BRINE CAM UP FLOW ASSY 5650

24503

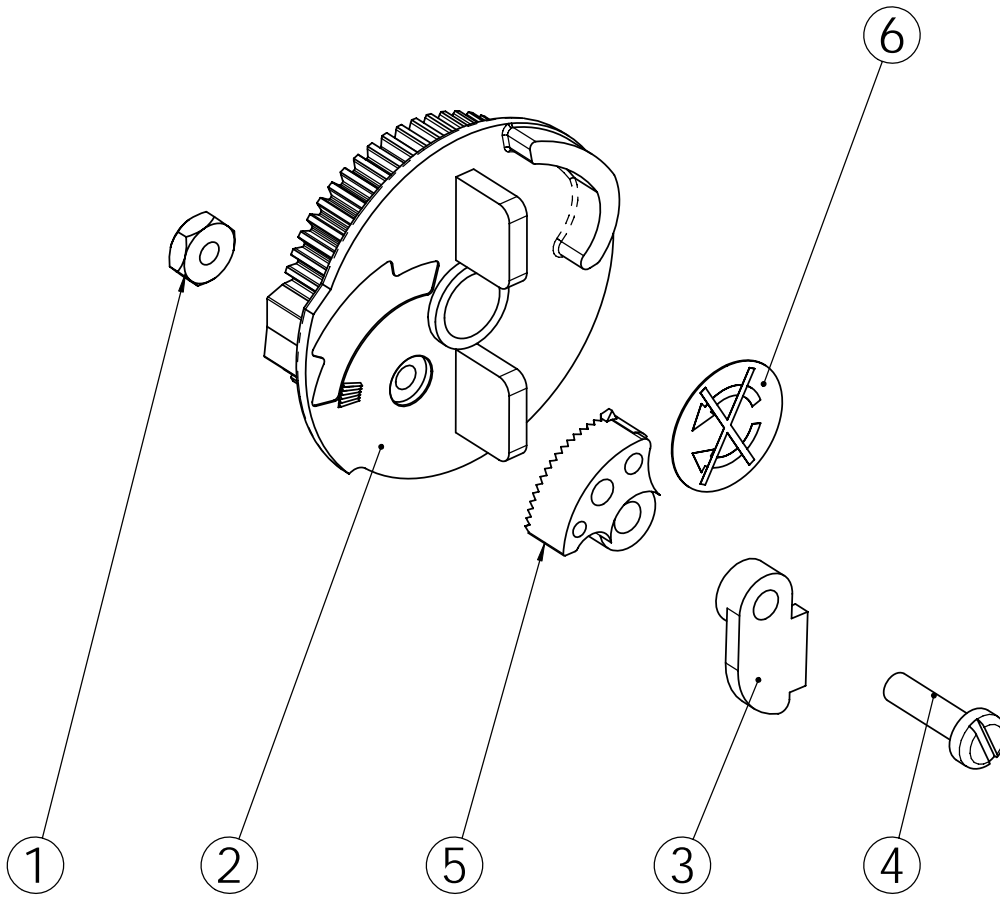
REVISIONS				
ECN	Rev.	Description	Date (dd/mm/yy)	Approved
F5381	D	BU11980 replace BR15571 (Use To Depletion)	02/09/2011	MAN
